# HISTORIC AND DESIGN REVIEW COMMISSION

March 3, 2021

**HDRC CASE NO:** 2021-072  
**COMMON NAME:** ROW near 304 E Pecan  
**ZONING:** D  
**CITY COUNCIL DIST.:** 1  
**APPLICANT:** Kevin Bowyer/Modus LLC  
**OWNER:** CITY OF SAN ANTONIO  
**TYPE OF WORK:** Replace an existing streetlight pole with a new pole with network node equipment  
**APPLICATION RECEIVED:** October 06, 2020  
**60-DAY REVIEW:** Not applicable due to City Council Emergency Orders  
**CASE MANAGER:** Huy Pham

The applicant is requesting a Certificate of Appropriateness for approval to replace the streetlight at the right-of-way near 304 E Pecan with a new pole with network node equipment in accordance with *CPS Energy: Downtown Street Light Replacement Pilot* Program approved by the HDRC on August 24, 2019, (returning request 2020-19286 - MARTIN\_ST\_MARKS\_SC).

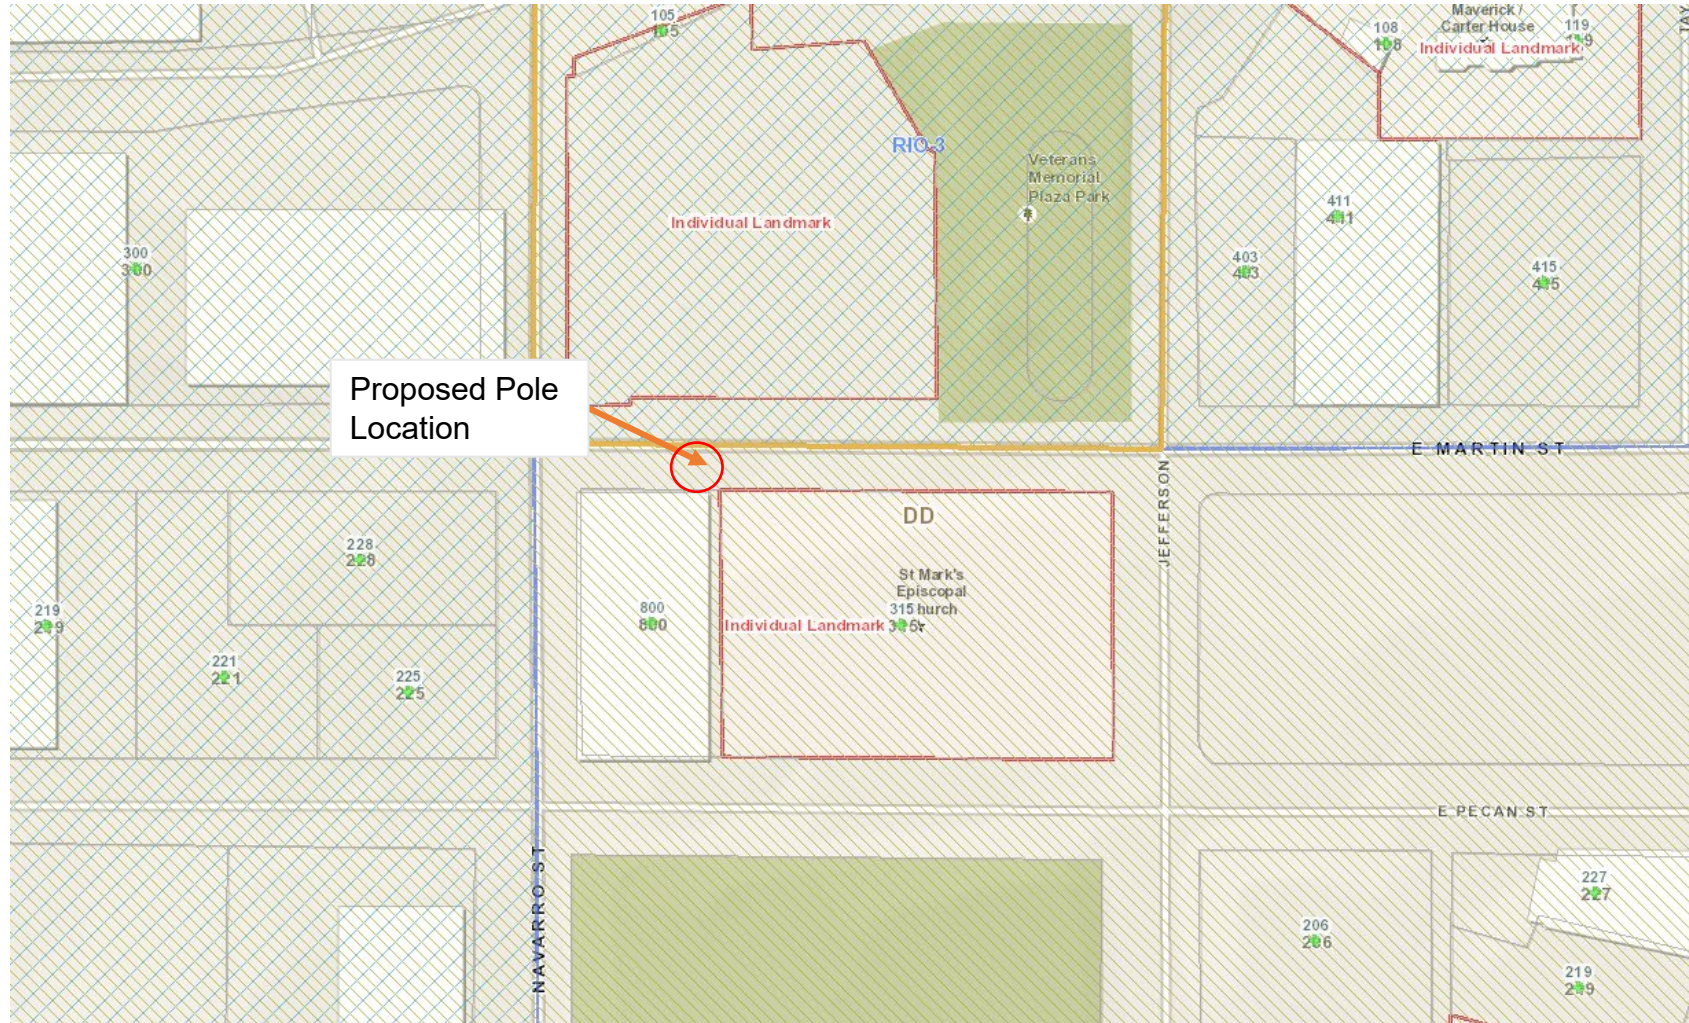
This application was originally on the October 21, 2020 HDRC agenda but was subsequently pulled off the agenda by a couple members of the HDRC due to concerns of the pole being directly in front of the front façade of the adjacent building.

Verizon met with the HDRC subcommittee on October 28<sup>th</sup>, 2020 to discuss the concerns some of the commission members had regarding the location of the replacement CPS streetlight. Directive from that meeting was to explore options with CPS on the feasibility of shifting the replacement of the replacement streetlight to a location that would be between two buildings rather than directly in front of the façade.

Unfortunately shifting the replacement pole to either ends of the adjacent building are not feasible. On the east side of the building, there is a drainage ditch and existing underground utilities in the area. There is not enough room for Verizon to pour a new foundation. On the west side of the building, there is also a drainage ditch but it would also be encroaching into the parking lot driveway exit.

Drainage "ditch" and  
existing underground  
utilities

Proximity parking lot  
exit/entrance
